Docket Item # 3
BAR CASE # 2008-0168

BAR Meeting
January 7, 2009

ISSUE: Alterations
APPLICANT: Elizabeth Reno and Roy Wuchitech
LOCATION: 408 North Union Street
ZONE: RM/Residential

BAR CASE #2008-0168, 0245

Figure 2: Proposed Union Street Elevation

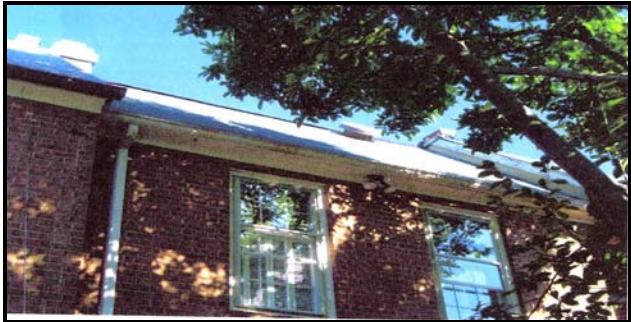
According to the *Design Guidelines*, when installing a new dormer “The style of the dormer should be appropriate to the architectural style of the existing structure.” In Staff’s opinion, because the houses in this development along North Union are not historic and some have experienced alterations, including new Palladian-style windows of differing styles, Staff does not conceptually have an objection to alterations to this property, which may include a new dormer or roof top deck. However, with the current proposal, the size of the new dormer is almost identical to the one submitted for the October 15th hearing. As originally submitted for the October hearing, the drawing showed the total width of the dormers as 10’4,” however upon clarification by the applicant for the current submittal, the measurement on the drawing provided did not include exterior trim on the outside of the windows, therefore the proposed dormers submitted on September 12, 2008 was in fact approximately 11’8” in total width. Based on this corrected information, the width of the proposed dormer submitted to Staff on December 10, 2008 is 4” narrower than the original submission. In terms of the height, upon clarification by the applicant the original dimension of 6’ on the drawing did not include any trim work and therefore the total height of the dormers, including trim, measured 7’5” rather than 6’. The revised submission for the December 17th hearing maintains the 7’5” height measurement. From the corrected information provided by the applicant, the current dormer has been reduced in width by 4” but has not been reduced in height from the October submittal.

The Design Guidelines generally discourage the use of simulated divided light windows on front facades, however in this situation, due to the desire for the new window to have the same muntin profile as the remaining windows on the façade, Staff believes the use of simulated divided lights would be appropriate. Furthermore, as a result of the fact that the siding on the dormer will be minimally visible and, due to its location, difficult to maintain, staff finds that the use of Hardiplank would not be an inappropriate building material for this alteration.

Figure 5: Overlay comparing submission for 10/15/2008 BAR hearing with submission for 12/17/2008 BAR hearing.

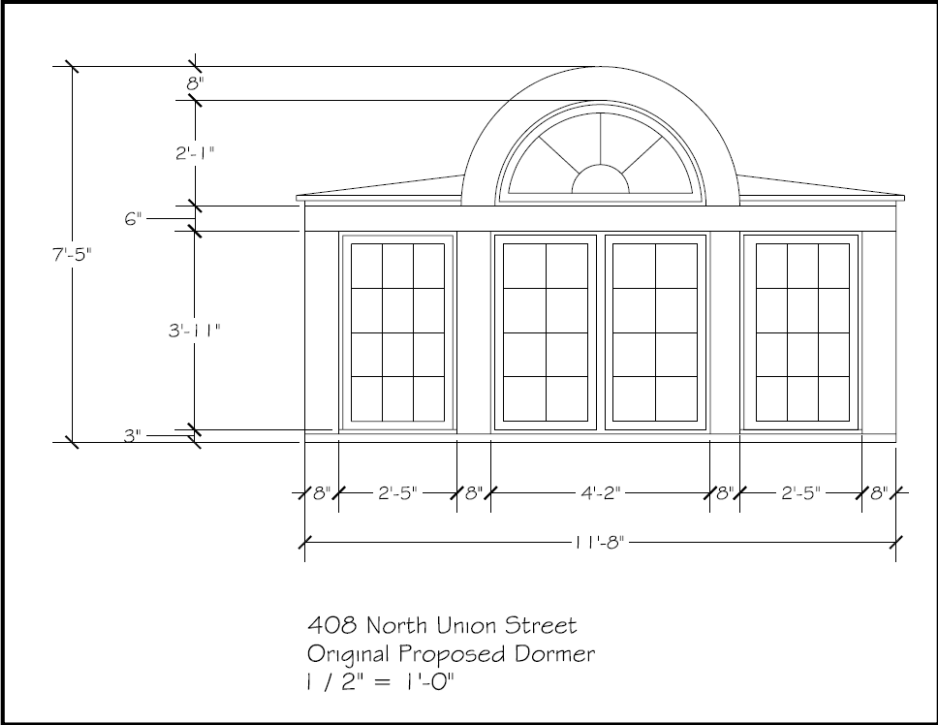
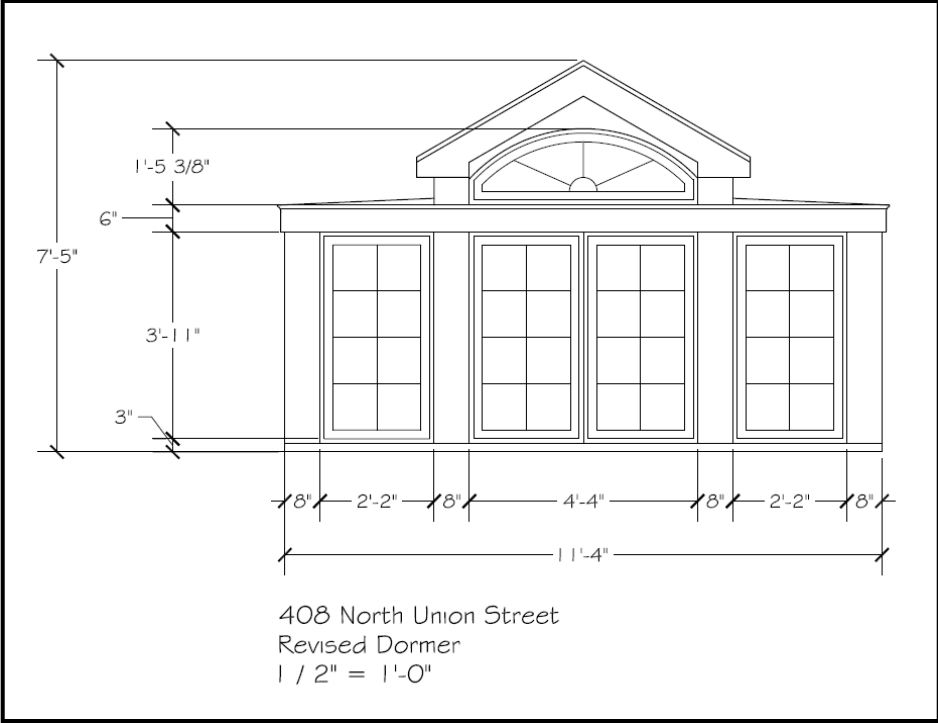
As stated above, Staff is concerned that the current proposal for the new dormers does not adequately address the concerns of the Board from the October hearing in respect to the appropriateness, style and the mass of the proposed Palladian-style windows. While the design of the dormer has been altered from the prior rounded form, the size and scale of the dormer has not been sufficiently revised to address the concerns expressed by the Board. Therefore, Staff recommends deferral of the application for restudy.

IV. STAFF RECOMMENDATION: Staff recommends deferral of the application for restudy.
